Project **IEEE 802.16 Broadband Wireless Access Working Group** <<http://ieee802.org/16>>

Title **Enhancement of Scanning and Association using SCAN-REQ/RSP**

Date Submitted **2004-06-25**

Re: This contribution is response to call for contribution about IEEE 802.16e-D3

**Figure E.2—Example BS advertisement and scanning (with association) by MSS request**

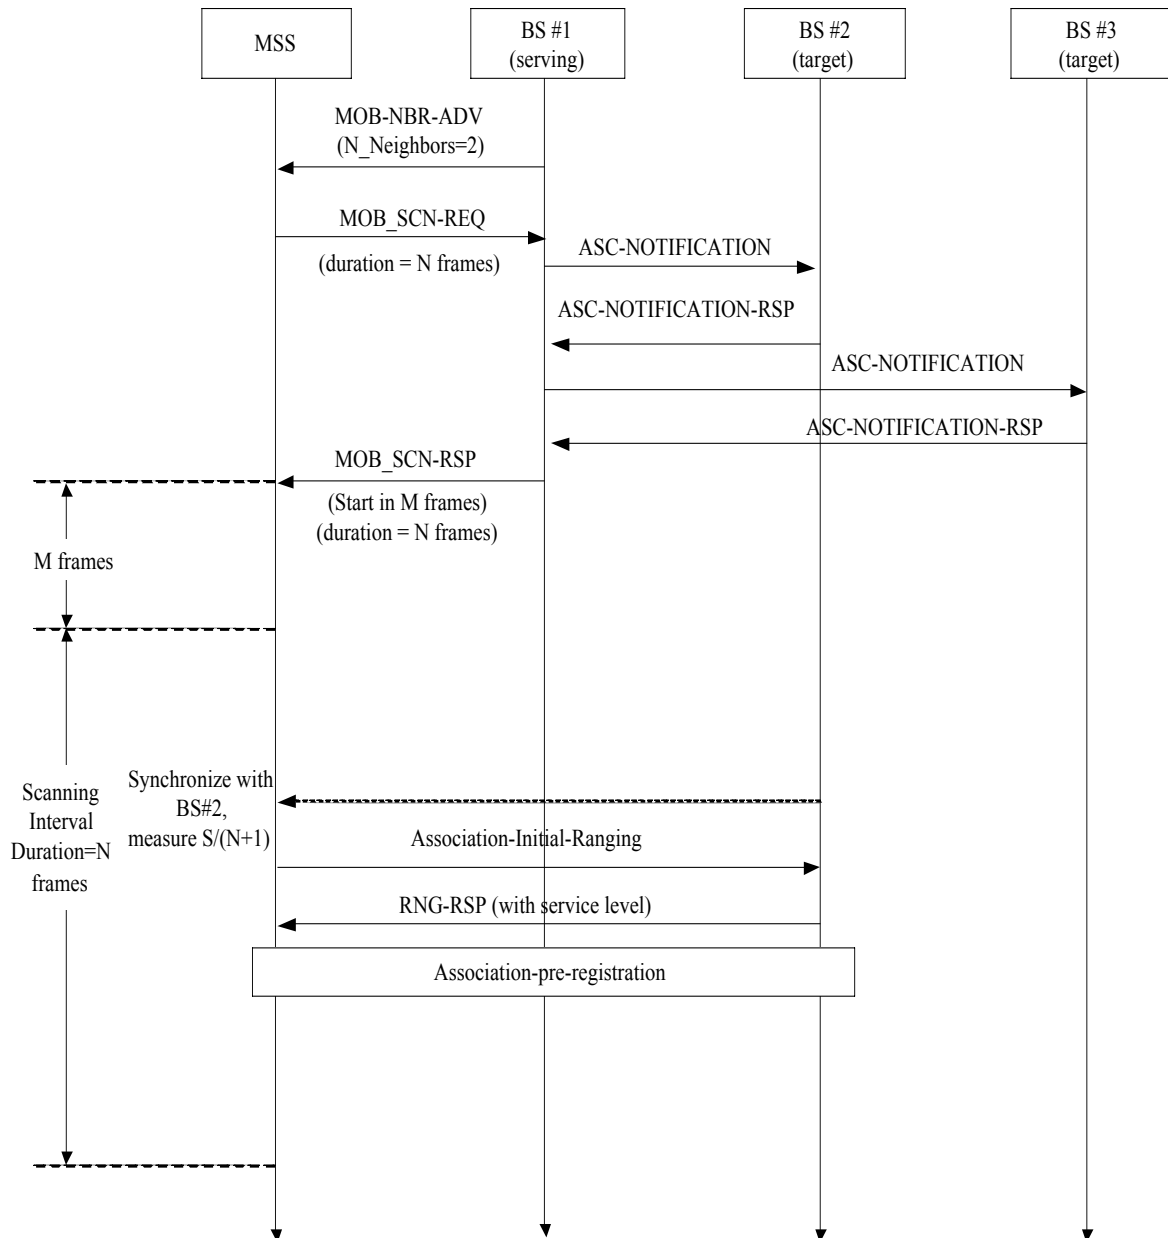
A modified MOB\_SCAN-REQ and MOB\_SCAN-RSP message are proposed to enhance MSS's operation of association for Scan Interval. ASC-Notification and ASC-Notification-RSP backbone messages are also proposed to inform target BSs of the information of MSS.

A MSS trying association can access to target BS through fast UL ranging IE provided by Target Neighbor BS. This case is the same as handoff case with above proposed messages and scenario.
